HORSHAM DISTRICT COUNCIL CONSULTATION

TO:	Horsham District Council – Planning Dept
LOCATION:	Northlands Melton Drive, Storrington
DESCRIPTION:	Outline application, with all matters reserved, for the phased development comprising: Phase 1 construction of the access road (to be delivered through a subsequent Reserved Matters Application pursuant to Outline Permission DC/24/2006); and Phase 2 residential development of up to 56 dwellings with associated landscaping, pedestrian and vehicular access
REFERENCE:	DC/26/1168
RECOMMENDATION:	Advice / No Objection / Objection / More Information / Modification / Refusal
SUMMARY OF COMMENTS & RECOMMENDATION: Land use quantities are required. The development appears to be lacking in the provision of amenity open space and parks. We would welcome the consideration of reorganisation of the housing to create a more substantial equilateral park in the northeastern area which can be used for kickabout and family games. The quantity associated with play and youth could be provided in the form of a small outdoor gym in a cluster on the edge of the park. This could be used by all generations and have proved very popular across the Horsham District. The

Quantity Provision:

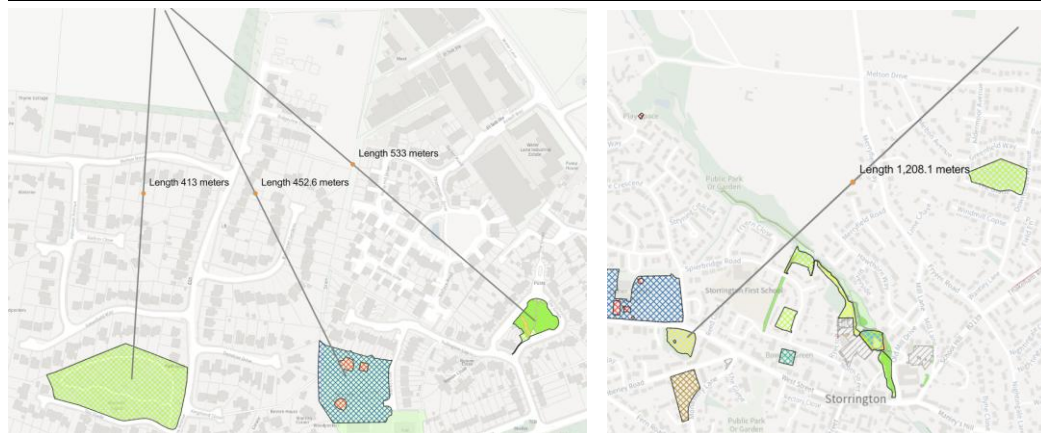
Type of space	Required (sqm)	Delivered (sqm)	Location & comments based on plans below
Parks & Gardens	1855	?	Lacking in suitable sized space – minimum 500sqm.
Amenity	780	?	Lacking in usable amenity space – minimum flat 500sqm, 20m width
Natural & semi-natural	3266	?	Provided – quantity needed
Children's play	67	?	Provided – but not necessary for the size of a LEAP, considering the development to the west.
Young people	54	?	Lacking in provision for young people.
Allotments	242	?	Allotments are being proposed to the south of Storrington (Ravenscroft site), however these are more than the 1km accessibility threshold.

The developer needs to provide a land use table matching the categories above which details what quantity of open space is being provided on site. Note that Parks and Gardens and Amenity open space must be at least 0.05 hectares and accord with the description in the OSSR. For example, amenity open space must be a minimum length and breadth of 20m.
